Non-Airliner Rear Suspension Crossmember Fastener Change

31-016

Western Star Service Bulletin

Fig. 1, New High Friction Nut

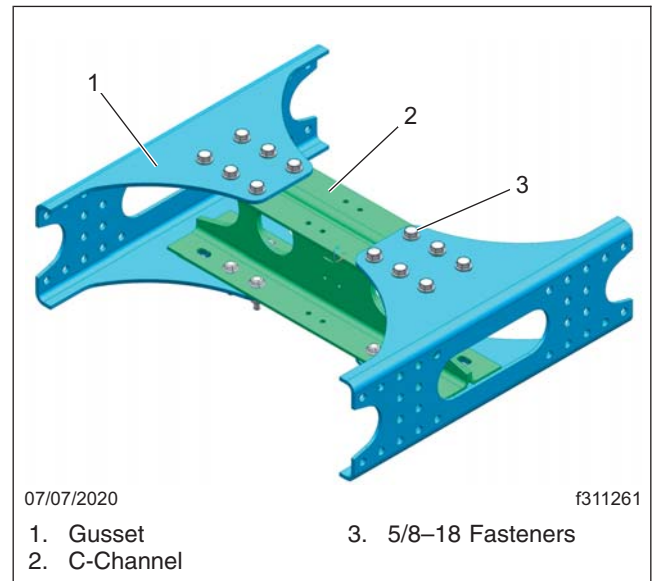
With the start of production on March 2, 2020, the fasteners used to assemble the non-Airliner rear suspension (bogie) crossmember have changed. The rear suspension bogie crossmember gussets to the C-channel will be assembled with 5/8–18 fasteners. This change includes a revision to a higher friction nut that requires an increase in tightening torque. The new higher friction nut can be identified by its green color. See **Fig. 1**. If the crossmember gusset to the C-channel mounting hardware is being removed, replace with new hardware as indicated by the part numbers in **PartsPro®**.
